**RE: Tailwaters at Stagecoach Prelim Subdivision Plan**

Please find below, responses to your September 10<sup>th</sup> comment letter for the Tailwaters Preliminary Plan Application which was submitted on January 15<sup>th</sup>, 2024 with additional clarifications and information provided on July 31, 2024 in response to the County comment letter on June 7<sup>th</sup>, 2024. The responses below, together with the revised plans and studies which have been uploaded to the County website, reflect any revisions necessary to address the items identified by Planning Staff and referral agencies. We look forward to scheduling a hearing with Planning and the County Commissioners of this Preliminary Subdivision package in the very near future.

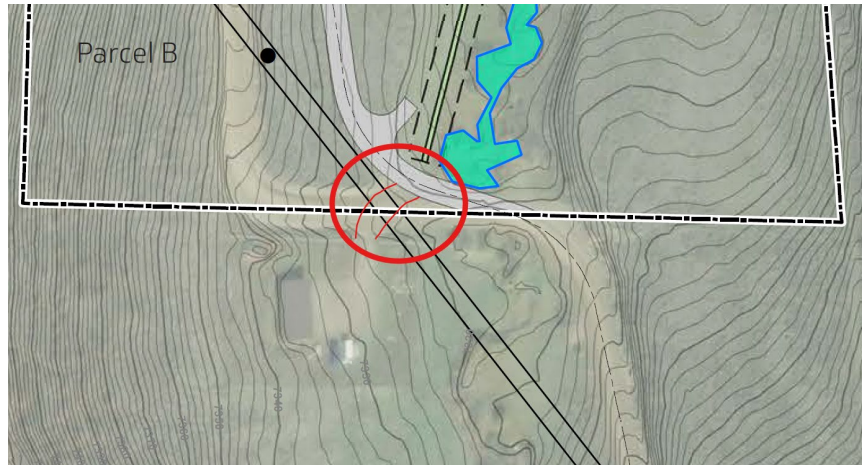
30. The Farrell's have a driveway that will need to be extended due to the relocation of CR 16. How much will it have to be extended? **There should be no need to extend the Farrell's driveway as it will continue to connect to the current location of CR 16 which will connect to the relocated CR 16 via an easement provided by Tailwaters. The former section of CR 16 which will now be within the easement will provide a direct connection to the relocated CR 16 as shown below.**
